# **APPENDIX A: Facility Reports**

City Hall - Exterior  
 2600 Fresno Street, Fresno

City Hall - North Wing - Third Floor  
 2600 Fresno Street, Fresno

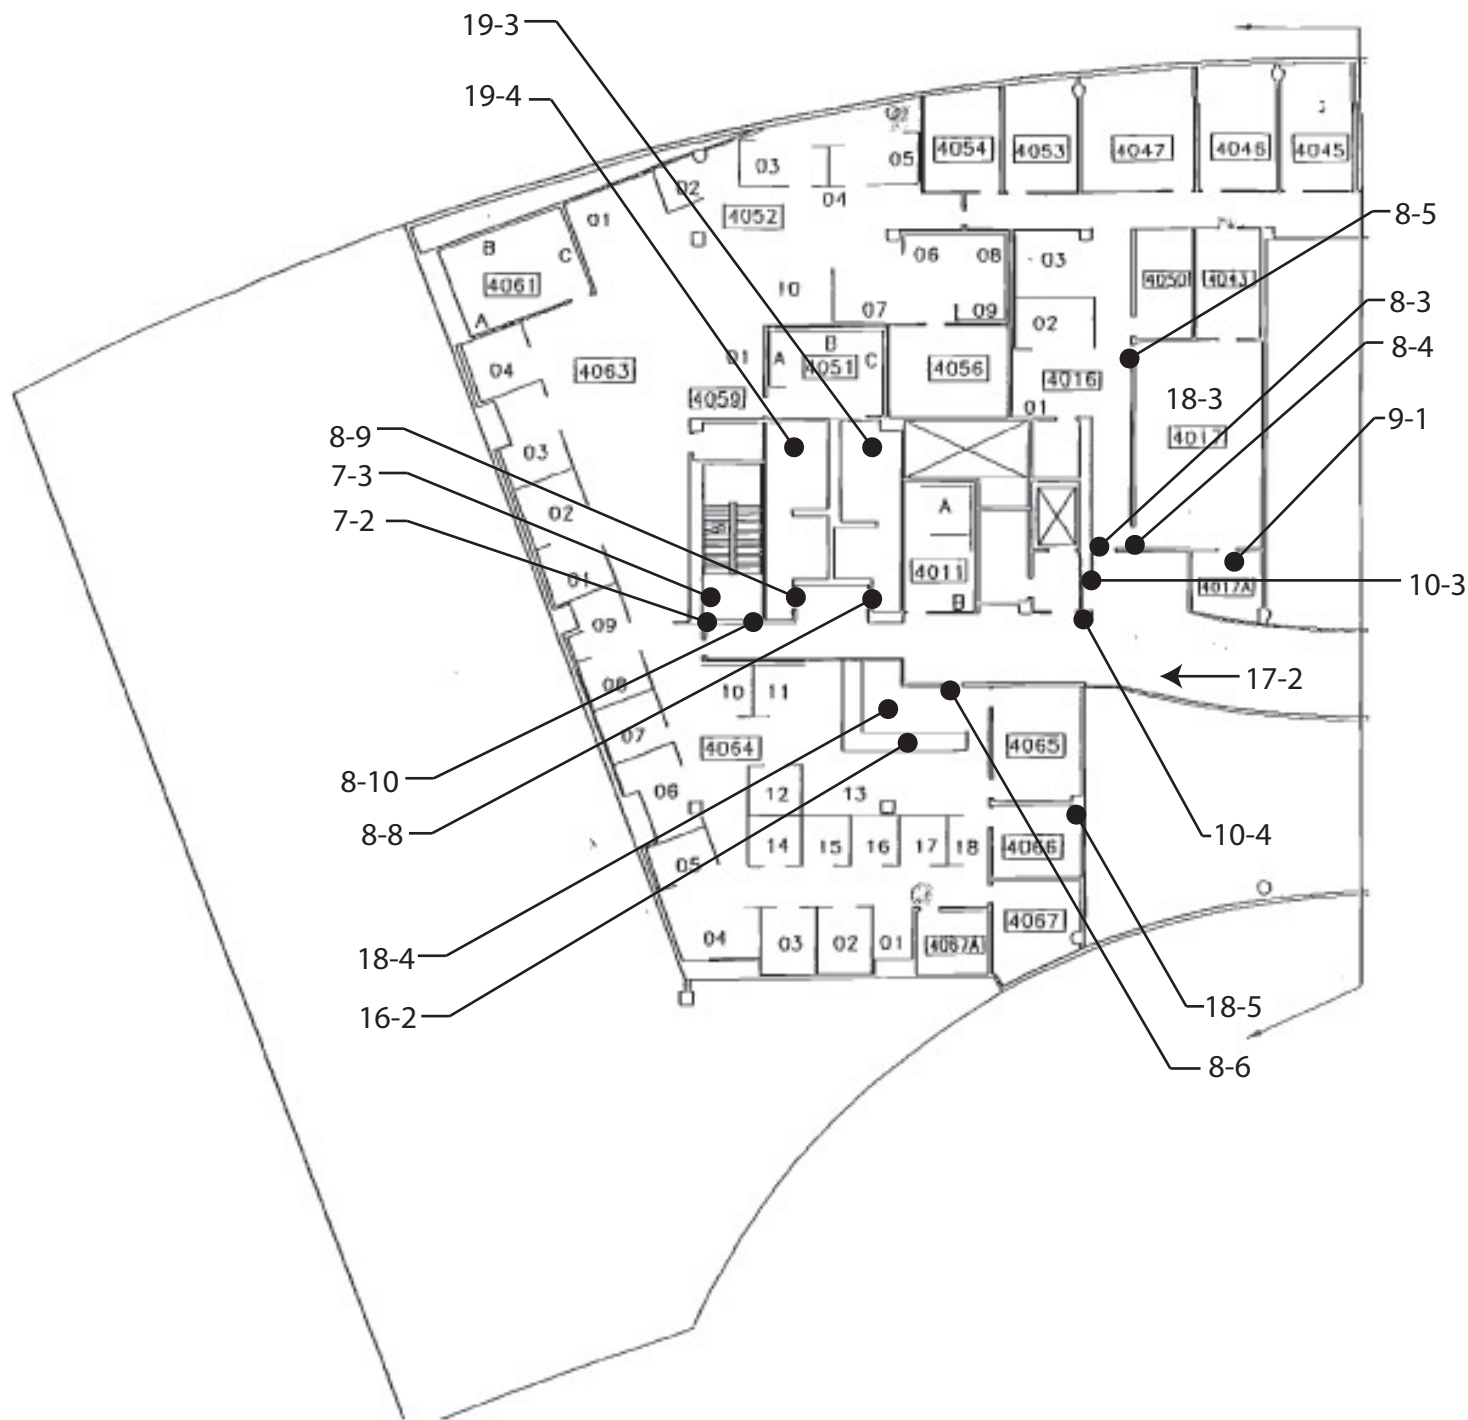
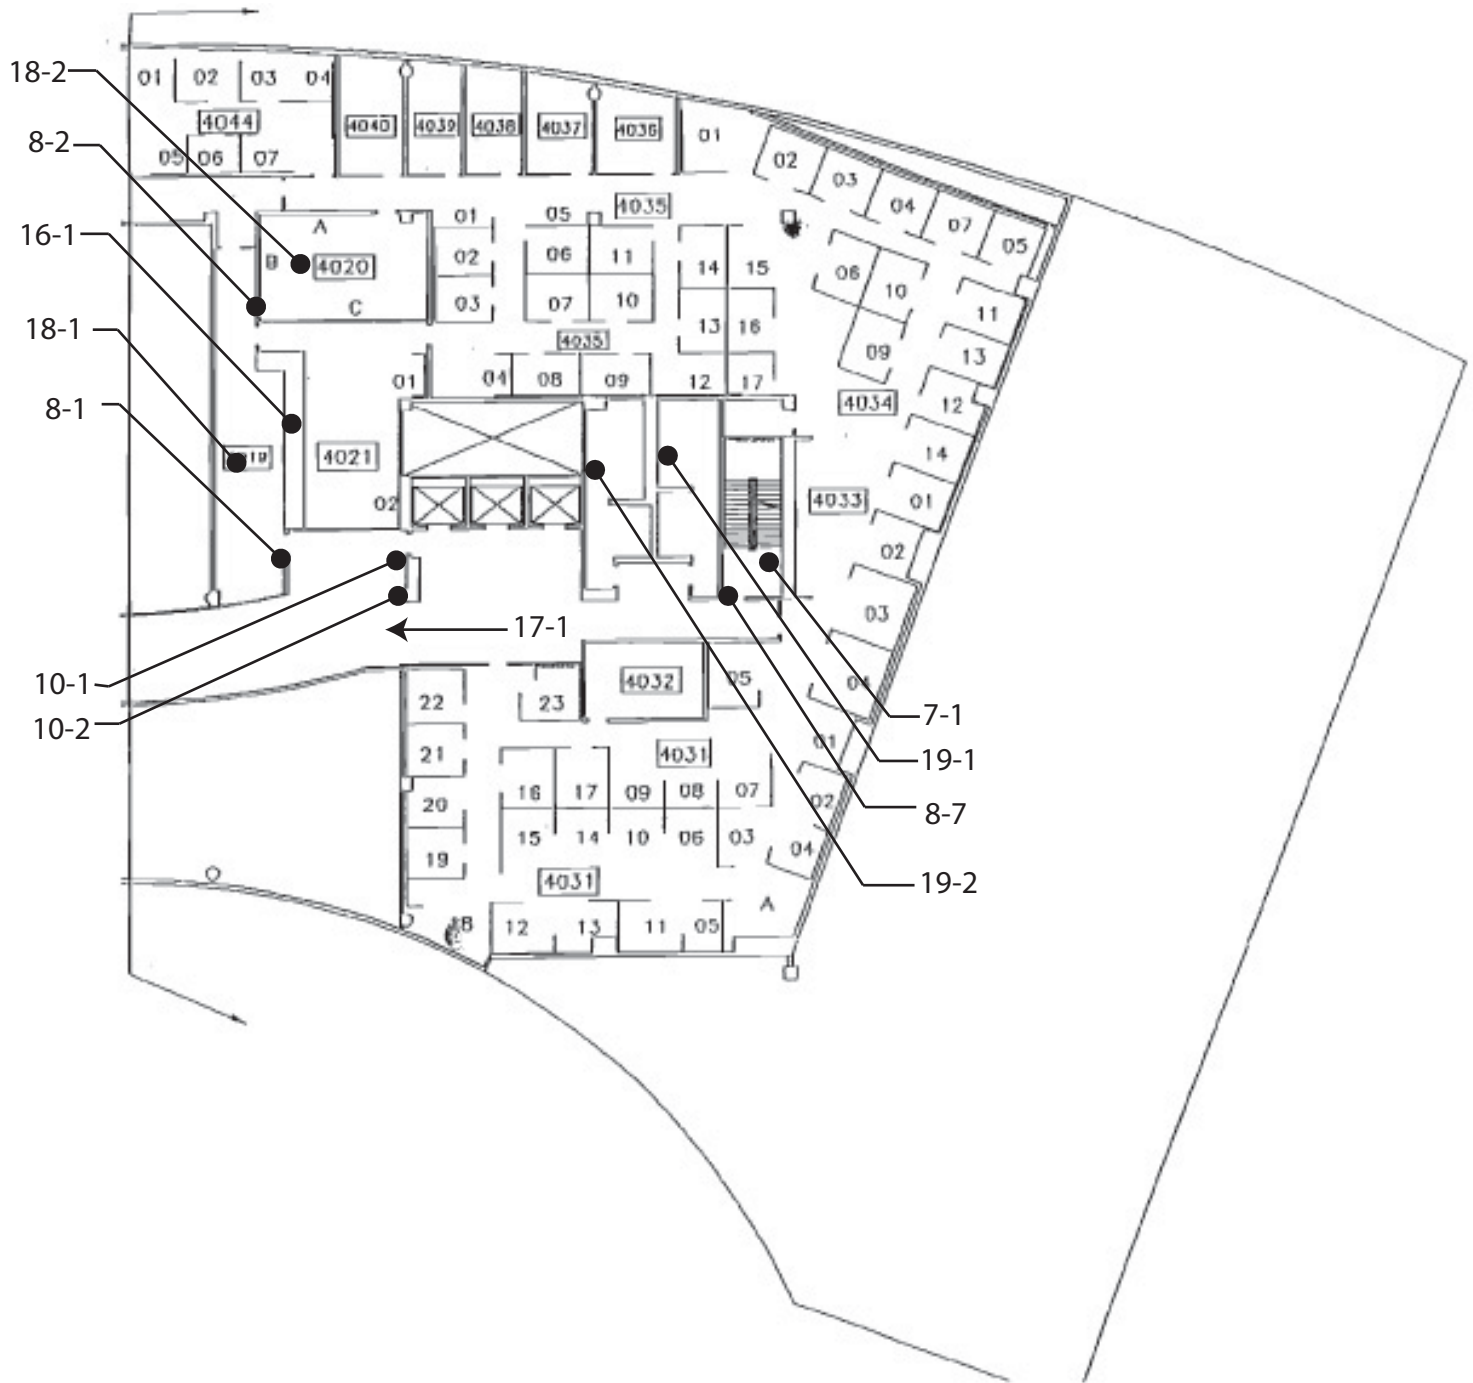
Federal: 4.4.1		
<b>7 - 2</b>	<b>Hazard</b>	Priority:4
<b>Remove overhanging or protruding objects</b>		\$100
Notes: Pipe is 73-1/2" (80" min) above the finished floor.		
State: 1133B.8.2, 1133B.8.6.2		
Federal: 4.4.2		
<b>7 - 3</b>	<b>Hazard</b>	Priority:4
<b>Remove overhanging or protruding objects</b>		\$100
Notes: Standpipe protrudes 23-3/4" (4" max) and is 27-3/4" (not between 27" to 80") above the finished floor.		
State: 1133B.8.6.1		
Federal: 4.4.1		
<b>8 - 1</b>	<b>Door/Gate</b>	Priority:2
<b>Adjust door closer</b>		\$100
Notes: Operating effort is 8 lbs (5 lbs max).		
State: 1133B.2.5		
Federal: 4.13.11

<b>Floor 3</b>		
<b>8 - 9</b>	<b>Door/Gate</b>	Priority:2
<b>Adjust door closer</b>		\$100
Notes: Operating effort is 10 lbs (5 lbs max).		
State: 1133B.2.5		
Federal: 4.13.11		
<b>8 - 10</b>	<b>Door/Gate</b>	Priority:2
<b>Adjust door closer</b>		\$100
Notes: Operating effort is 7 lbs (5 lbs max).		
State: 1133B.2.5		
Federal: 4.13.11		
<b>8 - 11</b>	<b>Door/Gate</b>	Priority:4
<b>Adjust door closer</b>		\$100
Notes: Operating effort is 9 lbs (5 lbs max).		
State: 1133B.2.5		
Federal: 4.13.11		
<b>Replace or adjust door hardware</b>		\$300
Notes: Door hardware is 56" (30" to 44") above the finished floor. Handle requires grasping and twisting.		
State: 1133B.2.5.2		
Federal: 4.13.9		
<b>8 - 12</b>	<b>Door/Gate</b>	Priority:2
<b>Adjust door closer</b>		\$100
Notes: Operating effort is 7 lbs (5 lbs max).		
State: 1133B.2.5		
Federal: 4.13.11		
<b>8 - 13</b>	<b>Door/Gate</b>	Priority:2
<b>Adjust door closer</b>		\$100

Notes: Operating effort is 10 lbs (5 lbs max).	
State: 1133B.2.5	
Federal: 4.13.11	
<b>Provide additional strike edge clearance</b>	\$3,000
Notes: Strike-edge clearance on push-side of door is 3" (12" min).	
State: 1133B.2.4.3	
Federal: 4.13.6

<b>Floor 3</b>	
<b>8 - 19 Door/Gate</b>	Priority: C
<b>Adjust door closer</b>	\$100
Notes: Operating effort is 13 lbs (5 lbs max).	
State: 1133B.2.5	
Federal: 4.13.11	
<b>Provide additional strike edge clearance</b>	\$3,000
Notes: Strike-edge clearance on swing-side is not provided (18" min).	
State: 1133B.2.4.3	
Federal: 4.13.6	
<b>8 - 20 Door/Gate</b>	Priority: C
<b>Provide additional strike edge clearance</b>	\$3,000
Notes: Strike-edge clearance on push-side of door is 1-3/4" (12" min).	
State: 1133B.2.4.3	
Federal: 4.13.6	
<b>8 - 21 Door/Gate</b>	Priority: 2
<b>Adjust door closer</b>	\$100
Notes: Operating effort is 19 lbs (5 lbs max).	
State: 1133B.2.5	
Federal: 4.13.11	
<b>Install or modify permanent room signs</b>	\$250
Notes: Braille is not provided.	
State: -	
Federal: 1117B.5.7, 4.30.6	
<b>8 - 22 Door/Gate</b>	Priority: 2
<b>Adjust door closer</b>	\$100
Notes: Operating effort is 12 lbs (5 lbs max).	
State: 1133B.2.5

<b>Floor 3</b>	
<b>10 - 1 Drinking Fountain</b>	Priority: 4
<b>Replace or reposition drinking fountain</b>	\$5,000
Notes: Depth is 9-1/2" (18" min). "Hi-lo" fountain is not provided.	
State: 1115B.4.6 #1, 1117B.4.6 #2	
Federal: 4.1.6, 4.15.5	
<b>Replace or adjust water controls</b>	\$500
Notes: Operating effort is 6 lbs (5 lbs max).	
State: 1115B.4.6 #4	
Federal: 4.15.4	
<b>10 - 2 Drinking Fountain</b>	Priority: 4
<b>Replace or reposition drinking fountain</b>	\$5,000
Notes: Depth is 9-1/2" (18" min). "Hi-lo" fountain is not provided.	
State: 1115B.4.6 #1, 1117B.4.6 #2	
Federal: 4.1.6, 4.15.5	
<b>Replace or adjust water controls</b>	\$500
Notes: Operating effort is 6 lbs (5 lbs max).	
State: 1115B.4.6 #4	
Federal: 4.15.4	
<b>10 - 3 Drinking Fountain</b>	Priority: 2
<b>Replace or reposition drinking fountain</b>	\$5,000
Notes: Depth is 9-1/2" (18" min). "Hi-lo" fountain is not provided.	
State: 1115B.4.6 #1, 1117B.4.6 #2

Federal: 4.1.6, 4.15.5	
<b>Replace or adjust water controls</b>	\$500
Notes: Operating effort is 7 lbs (5 lbs max).	
State: 1115B.4.6 #4	
Federal: 4.15.4	
<b>10 - 4 Drinking Fountain</b>	Priority: 2
<b>Replace or reposition drinking fountain</b>	\$5,000
Notes: Depth is 9-1/2" (18" min). "Hi-lo" fountain is not provided.	
State: 1115B.4.6 #1, 1117B.4.6 #2	
Federal: 4.1.6, 4.15.5	
<b>Replace or adjust water controls</b>	\$500
Notes: Operating effort is 6 lbs (5 lbs max).	
State: 1115B.4.6 #4	
Federal: 4.15.4

<b>Floor 3</b>	
<b>11 - 1 Telephone</b>	Priority: 3
<b>Provide new phone equipment</b>	\$600
Notes: Height from the floor to the bottom of the enclosure is 28-1/2" (27" max).	
State: 1117B.2.7.1	
Federal: 4.31.4	
<b>11 - 2 Telephone</b>	Priority: 4
<b>Provide TDD equipment</b>	\$1,200
Notes: TDD is not provided.	
State: 1117B.2.9.2 #1, 1117B.2.9.2 #2	
Federal: 4.31.9 #1, 4.31.9 #2	
<b>Provide new phone equipment</b>	\$600
Notes: Height from the floor to the bottom of the enclosure is 28-1/2" (27" max). Enclosure extends 14-3/4" (12" max) from the front surface of the telephone.	
State: 1117B.2.7 #2, 1117B.2.7.1	
Federal: 4.31.4	
<b>16 - 1 Transaction Counter</b>	Priority: 2
<b>Provide an accessible counter</b>	\$4,000
Notes: Transaction counter is 42-3/4" (28" to 34") above the finished floor.	
State: 1122B.5	
Federal: 4.32.4	
<b>16 - 2 Transaction Counter</b>	Priority: 2
<b>Provide an accessible counter</b>	\$4,000

Notes: Transaction counter is 40-1/2" (28" to 34") above the finished floor.	
State: 1122B.5	
Federal: 4.32.4	
<b>16 - 3 Transaction Counter</b>	Priority: 2
<b>Provide an accessible counter</b>	\$4,000
Notes: Transaction counter is 45-1/2" (28" to 34") above the finished floor.	
State: 1122B.5	
Federal: 4.32.4	
<b>16 - 4 Transaction Counter</b>	Priority: 2
<b>Provide an accessible counter</b>	\$4,000
Notes: Transaction counter is 45-1/2" (28" to 34") above the finished floor.	
State: 1122B.5	
Federal: 4.32.4

<b>Floor 3</b>	
<b>16 - 5 Transaction Counter</b>	Priority:2
<b>Provide an accessible counter</b>	\$4,000
Notes: Transaction counter is 45-3/4" (28" to 34") above the finished floor.	
State: 1122B.5	
Federal: 4.32.4	
<b>16 - 6 Transaction Counter</b>	Priority:2
<b>Provide an accessible counter</b>	\$4,000
Notes: Transaction counter is 46" (28" to 34") above the finished floor.	
State: 1122B.5	
Federal: 4.32.4	
<b>17 - 2 Corridor / Aisle</b>	Priority:4
<b>Reposition controls and outlets</b>	\$250
Notes: Electrical outlets are 11" (15" min) above the finished floor.	
State: 1117B.6.3	
Federal: 4.27.3	
<b>17 - 3 Corridor / Aisle</b>	Priority:4
<b>Reposition controls and outlets</b>	\$250
Notes: Electrical outlets are 11-3/4" (15" min) above the finished floor.	
State: 1117B.6.3	
Federal: 4.27.3	
<b>17 - 4 Corridor / Aisle</b>	Priority:3
<b>Reposition controls and outlets</b>	\$250
Notes: Electrical outlets are 12" (15" min) above the finished floor.

<b>Floor 3</b>	
<b>19 - 1 Multiple User Restroom</b>	<b>Priority:2</b>
<b>Modify lavatory/counter clearances</b>	<b>\$3,500</b>
Notes: Height of the counter is 35-1/2" (34" max) above the finished floor. Clear space beneath the lavatory sink, from the front to the wall is 14" (17" min) deep. Provide new lavatory.	
State: 1115B.4.3 #2	
Federal: 4.19.2	
<b>Provide or replace stall door hardware</b>	<b>\$100</b>
Notes: U-shaped handle is not provided on the back side of stall door.	
State: 1115B.3.1 #4.5	
Federal: 4.13.9	
<b>Modify stall partitions and doors</b>	<b>\$800</b>
Notes: Door width for side-entry stall is 33" (34" min).	
State: 1115B.3.1 #4.4	
Federal: -	
<b>Modify stall partitions and doors</b>	<b>\$500</b>
Notes: 11" (32" min) from the edge of the toilet to the wall at the other side.	
State: 1115B.4.1 #1	
Federal: 4.17.3	
<b>Modify stall partitions and doors</b>	<b>\$500</b>
Notes: Stall width is 59" (60" min).

State: -	
Federal: 4.17.3	
<b>Reposition toilet flush controls</b>	<b>\$750</b>
Notes: Flush control is not located on the wide side.	
State: 1115B.4.1 #5	
Federal: 4.16.5	
<b>Replace or reposition dispensers or mirrors</b>	<b>\$100</b>
Notes: Seat cover dispenser is 42" (40" max) above the finished floor.	
State: 1115B.8.3	
Federal: 4.23.7

<b>Floor 3</b>	
<b>19 - 2 Multiple User Restroom</b>	<b>Priority:2</b>
<b>Modify lavatory/counter clearances</b>	<b>\$3,500</b>
Notes: Height of the counter is 35-1/2" (34" max) above the finished floor. Clear space beneath the lavatory sink, from the front to the wall is 14" (17" min) deep. Provide new lavatory.	
State: 1115B.4.3 #2	
Federal: 4.19.2	
<b>Provide or replace stall door hardware</b>	<b>\$100</b>
Notes: U-shaped handle is not provided on the back side of stall door.	
State: 1115B.3.1 #4.5	
Federal: 4.13.9	
<b>Modify stall partitions and doors</b>	<b>\$800</b>
Notes: Door width for side-entry stall is 33-1/2" (34" min).	
State: 1115B.3.1 #4.4	
Federal: -	
<b>Modify stall partitions and doors</b>	<b>\$500</b>
Notes: Stall width is 42" (60" min).	
State: -	
Federal: 4.17.3	
<b>Reposition toilet flush controls</b>	<b>\$750</b>
Notes: Flush control is not located on the wide side.	
State: 1115B.4.1 #5

<b>Floor 3</b>	
<b>19 - 3</b>	<b>Multiple User Restroom</b> <span style="float: right;">Priority: 4</span>
<b>Modify lavatory/counter clearances</b>	<b>\$3,500</b>
Notes: Clear space beneath the lavatory sink, from the front to the wall is 14" (17" min) deep. The space under the bowl is 26" (27" min) when measured 8" in from the front edge. Height of the counter is 35-1/2" (34" max) AFF. Provide new lavatory.	
State: 1115B.4.3 #2	
Federal: 4.19.2	
<b>Provide or replace stall door hardware</b>	<b>\$100</b>
Notes: U-shaped handle is not provided on the back side of stall door.	
State: 1115B.3.1 #4.5	
Federal: 4.13.9	
<b>Modify stall partitions and doors</b>	<b>\$800</b>
Notes: Door width for side-entry stall is 33-1/2" (34" min).	
State: 1115B.3.1 #4.4	
Federal: -	
<b>Modify stall partitions and doors</b>	<b>\$500</b>
Notes: 10-1/4" (32" min) from the edge of the toilet to the wall at the other side.	
State: 1115B.4.1 #1

Floor 3	
19 - 3 Multiple User Restroom	Priority: 4
<b>Replace or modify grab bars</b>	<b>\$350</b>
Notes: Bars are mounted 34" (33") above the finished floor.	
State: 1115B.4.1 #3	
Federal: 4.17.6

Floor 3	
19 - 4 Multiple User Restroom	Priority: 4
<b>Modify lavatory/counter clearances</b>	<b>\$3,500</b>
Notes: Height of the counter is 35-1/2" (34" max) above the finished floor.	
State: 1115B.4.3 #2	
Federal: 4.19.2	
<b>Provide or replace stall door hardware</b>	<b>\$100</b>
Notes: U-shaped handle is not provided on the back side of stall door.	
State: 1115B.3.1 #4.5	
Federal: 4.13.9	
<b>Modify stall partitions and doors</b>	<b>\$800</b>
Notes: Door width for side-entry stall is 33" (34" min).	
State: 1115B.3.1 #4.4	
Federal: -	
<b>Modify stall partitions and doors</b>	<b>\$500</b>
Notes: Stall width is 59" (60" min).	
State: -	
Federal: 4.17.3	
<b>Reposition toilet flush controls</b>	<b>\$750</b>
Notes: Flush control is not located on the wide side.	
State: 1115B.4.1 #5	
Federal: 4.16.5	
<b>Replace or reposition dispensers or mirrors</b>	<b>\$100</b>
Notes: Seat cover dispenser is 41" (40" max) above the finished floor.

<b>Floor 3</b>	
<b>20 - 1 Single User Restroom</b>	Priority: 4
<b>Install sign</b>	\$250
Notes: Federal required signage is not provided on the latch side of the door. International Symbol of Accessibility is not provided.	
State: 1115B.6, 1117B.5.1 #1, 1117B.5.5 #3, 1117B.5.8.1.2	
Federal: 4.30.4	
<b>Modify lavatory/counter clearances</b>	\$3,500
Notes: Height of counter is 36-1/2" (34" max) above the finished floor.	
State: 1115B.4.3 #2	
Federal: 4.19.2	
<b>Insulate water lines</b>	\$100
Notes: Hot water and drain pipes are not insulated.	
State: 1115B.4.3 #4	
Federal: 4.19.4	
<b>Replace or reposition fixtures</b>	\$1,000
Notes: Clear space from the other wall to the centerline of the toilet is 25-1/2" (18").	
State: 1115B.4.1 #1	
Federal: 4.17.3	
<b>Reposition toilet flush controls</b>	\$750
Notes: Flush control is not located on the wide side.	
State: 1115B.4.1 #5	
Federal: 4.16.5

City Hall - North Wing - Fourth Floor  
 2600 Fresno Street, Fresno

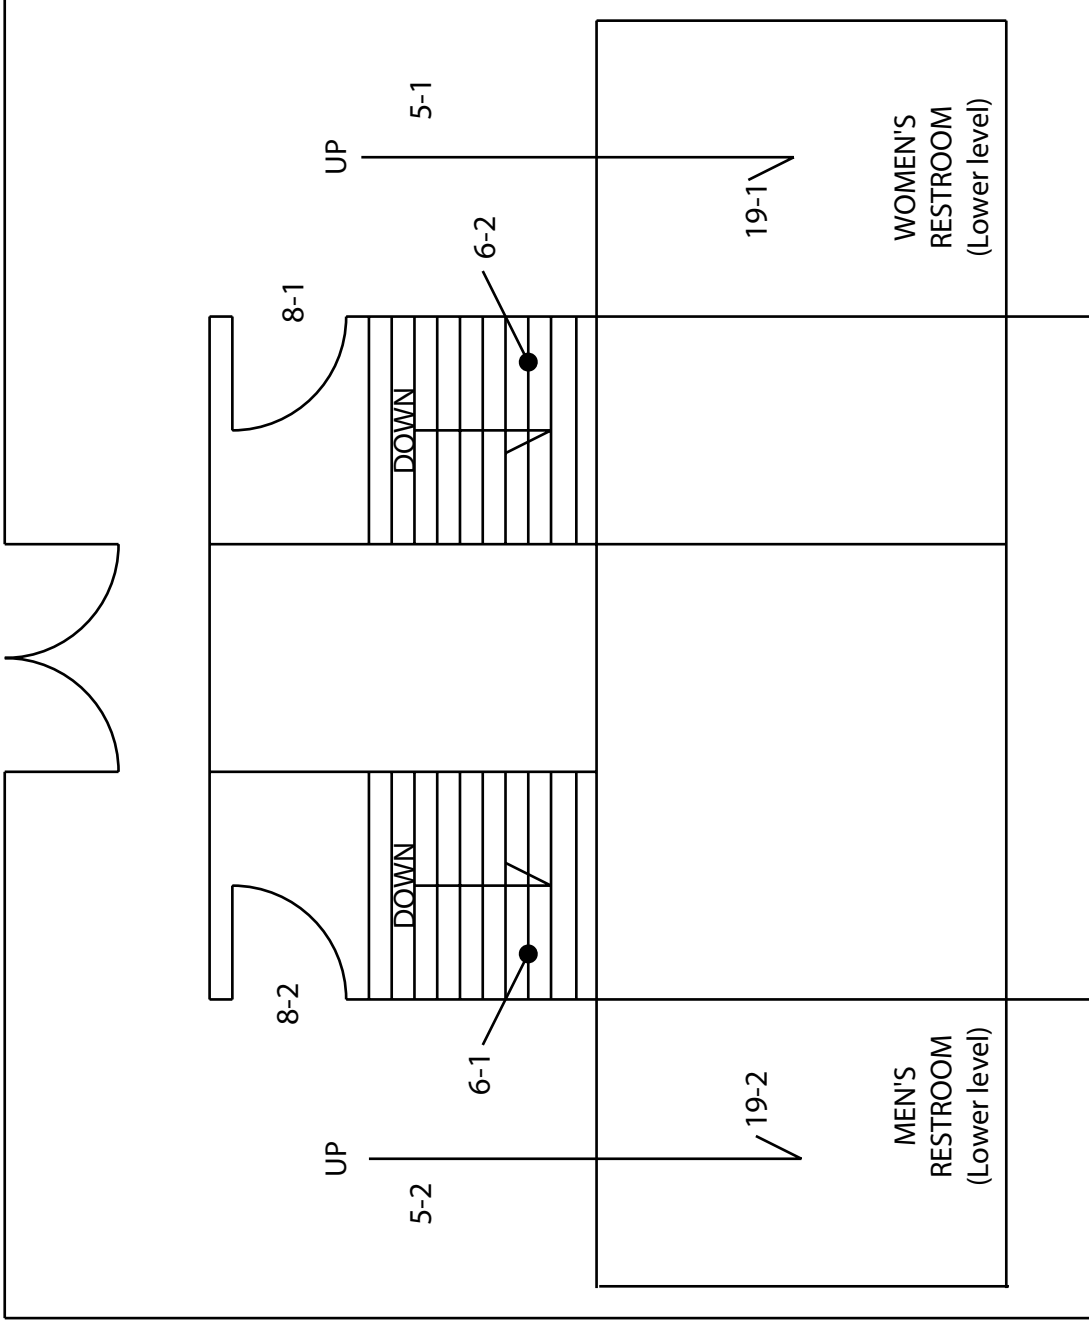
Floor 4		
<b>7 - 1</b>	<b>Hazard</b>	Priority: 4
<b>Remove overhanging or protruding objects</b>		\$100
Notes: Standpipe protrudes 21" (4" max) and is 28" ( not between 27" to 80") above the finished floor.		
State: 1133B.8.6.1		
Federal: 4.4.1		
<b>7 - 2</b>	<b>Hazard</b>	Priority: 4
<b>Remove overhanging or protruding objects</b>		\$100
Notes: Standpipe protrudes 23-1/4" (4" max) and is 27-3/4" (not between 27" to 80") above the finished floor.		
State: 1133B.8.6.1		
Federal: 4.4.1		
<b>7 - 3</b>	<b>Hazard</b>	Priority: 4
<b>Remove overhanging or protruding objects</b>		\$100
Notes: Pipe is 73-1/2" (80" min) above the finished floor.		
State: 1133B.8.2, 1133B.8.6.2		
Federal: 4.4.2		
<b>8 - 1</b>	<b>Door/Gate</b>	Priority: 2
<b>Adjust door closer</b>		\$100
Notes: Operating effort is 9 lbs (5 lbs max).		
State: 1133B.2.5		
Federal: 4.13.11		
<b>8 - 2</b>	<b>Door/Gate</b>	Priority: 2
<b>Adjust door closer</b>		\$100

Notes: Depth is 9-1/2" (18" min). "Hi-lo" fountain is not provided.		
State: 1115B.4.6 #1, 1117B.4.6 #2		
Federal: 4.1.6, 4.15.5		
<b>10 - 3</b>	<b>Drinking Fountain</b>	Priority: 4
<b>Replace or reposition drinking fountain</b>		\$5,000
Notes: Height is 26" (27" min). Depth is 9-3/4" (18" min). "Hi-lo" fountain is not provided.		
State: 1115B.4.6 #1, 1115B.4.6 #2, 1117B.4.6 #2		
Federal: 4.1.6, 4.15.5		
<b>10 - 4</b>	<b>Drinking Fountain</b>	Priority: 4
<b>Replace or reposition drinking fountain</b>		\$5,000
Notes: Depth is 9-1/2" (18" min). "Hi-lo" fountain is not provided.		
State: 1115B.4.6 #1, 1117B.4.6 #2		
Federal: 4.1.6, 4.15.5

<b>Floor 4</b>		
<b>16 - 1</b>	<b>Transaction Counter</b>	Priority:2
	<b>Provide an accessible counter</b>	\$4,000
Notes: Transaction counter is 42-1/2" (28" to 34") above the finished floor.		
State: 1122B.5		
Federal: 4.32.4		
<b>16 - 2</b>	<b>Transaction Counter</b>	Priority:2
	<b>Provide an accessible counter</b>	\$4,000
Notes: Transaction counter is 42-3/4" (28" to 34") above the finished floor.		
State: 1122B.5		
Federal: 4.32.4		
<b>17 - 1</b>	<b>Corridor / Aisle</b>	Priority:4
	<b>Reposition controls and outlets</b>	\$250
Notes: Electrical outlets are 11" (15" min) above the finished floor.		
State: 1117B.6.3		
Federal: 4.27.3		
<b>17 - 2</b>	<b>Corridor / Aisle</b>	Priority:4
	<b>Reposition controls and outlets</b>	\$250
Notes: Electrical outlets are 11" (15" min) above the finished floor.		
State: 1117B.6.3		
Federal: 4.27.3		
	<b>Install visual fire alarms</b>	\$250
Notes: Visual fire alarm is 97" (80") above the finished floor. Lower visual fire alarm.

<b>Floor 4</b>	
<b>19 - 1 Multiple User Restroom</b>	<b>Priority:2</b>
<b>Insulate water lines</b>	<b>\$100</b>
Notes: Hot water and drain pipes are not insulated.	
State: 1115B.4.3 #4	
Federal: 4.19.4	
<b>Provide or replace stall door hardware</b>	<b>\$100</b>
Notes: U-shaped handle is not provided on the back side of stall door.	
State: 1115B.3.1 #4.5	
Federal: 4.13.9	
<b>Replace or reposition fixtures</b>	<b>\$1,000</b>
Notes: Space from the other wall to the centerline of the toilet is 19" (18").	
State: 1115B.7.1.3	
Federal: 4.17.3	
<b>Reposition toilet flush controls</b>	<b>\$750</b>
Notes: Flush control is not located on the wide side.	
State: 1115B.4.1 #5	
Federal: 4.16.5	
<b>Replace or reposition dispensers or mirrors</b>	<b>\$100</b>
Notes: Seat cover dispenser is 41" (40" max) above the finished floor.	
State: 1115B.8.3	
Federal: 4.23.7	
<b>Modify lavatory/counter clearances</b>	<b>\$3,500</b>
Notes: Height of counter is 36" (34" max) above the finished floor.

<b>Floor 4</b>	
<b>19 - 2 Multiple User Restroom</b>	<b>Priority:2</b>
<b>Insulate water lines</b>	<b>\$100</b>
Notes: Hot water and drain pipes are not insulated.	
State: 1115B.4.3 #4	
Federal: 4.19.4	
<b>Provide or replace stall door hardware</b>	<b>\$100</b>
Notes: U-shaped handle is not provided on the back side of stall door.	
State: 1115B.3.1 #4.5	
Federal: 4.13.9	
<b>Modify stall partitions and doors</b>	<b>\$800</b>
Notes: Door width for side-entry stall is 32" (34" min).	
State: 1115B.3.1 #4.4	
Federal: -	
<b>Replace or reposition dispensers or mirrors</b>	<b>\$100</b>
Notes: Seat cover dispenser is 41" (40" max) above the finished floor.	
State: 1115B.8.3	
Federal: 4.23.7	
<b>Increase or provide maneuvering or clear floor area</b>	<b>\$2,500</b>
Notes: Turning area is 57" (60" min).	
State: 1115B.3.1 #1	
Federal: 4.23.3	
<b>Modify lavatory/counter clearances</b>	<b>\$3,500</b>
Notes: Height of counter is 36" (34" max) above the finished floor.

<b>Floor 4</b>	
<b>19 - 3 Multiple User Restroom</b>	<b>Priority:2</b>
<b>Provide or replace stall door hardware</b>	<b>\$100</b>
Notes: U-shaped handle is not provided on the back side of stall door. Stall door is not self-closing.	
State: 1115B.3.1 #4.5	
Federal: 4.13.9	
<b>Modify stall partitions and doors</b>	<b>\$800</b>
Notes: Door width for side-entry stall is 33-1/2" (34" min).	
State: 1115B.3.1 #4.4	
Federal: -	
<b>Replace or reposition fixtures</b>	<b>\$1,000</b>
Notes: Space from the other wall to the centerline of the toilet is 17-1/2" (18").	
State: 1115B.7.1.3	
Federal: 4.17.3	
<b>Reposition toilet flush controls</b>	<b>\$750</b>
Notes: Flush control is not located on the wide side.	
State: 1115B.4.1 #5	
Federal: 4.16.5	
<b>Modify lavatory/counter clearances</b>	<b>\$1,500</b>
Notes: Height of counter is 36" (34" max) above the finished floor. Lower lavatory.	
State: 1115B.4.3 #2	
Federal: 4.19.2

<b>Floor 4</b>	
<b>19 - 4 Multiple User Restroom</b>	<b>Priority:2</b>
<b>Modify lavatory/counter clearances</b>	<b>\$3,500</b>
Notes: Height of counter is 36" (34" max) above the finished floor. Lower lavatory.	
State: 1115B.4.3 #2	
Federal: 4.19.2	
<b>Provide or replace stall door hardware</b>	<b>\$100</b>
Notes: Stall door is not self-closing. U-shaped handle is not provided on the back side of stall door.	
State: 1115B.3.1 #4.5	
Federal: 4.13.9	
<b>Modify stall partitions and doors</b>	<b>\$800</b>
Notes: Door width for side-entry stall is 33-1/2" (34" min).	
State: 1115B.3.1 #4.4	
Federal: -	
<b>Replace or reposition fixtures</b>	<b>\$1,000</b>
Notes: Space from the other wall to the centerline of the toilet is 16" (18").	
State: 1115B.7.1.3	
Federal: 4.17.3	
<b>Replace or reposition dispensers or mirrors</b>	<b>\$250</b>
Notes: Seat cover dispenser is 41" (40" max) above the finished floor.	
State: 1115B.8.3

Federal: 4.23.7	
<b>Modify stall partitions and doors</b>	<b>\$500</b>
Notes: Stall width is 59-1/2" (60" min).	
State: -	
Federal: 4.17.3
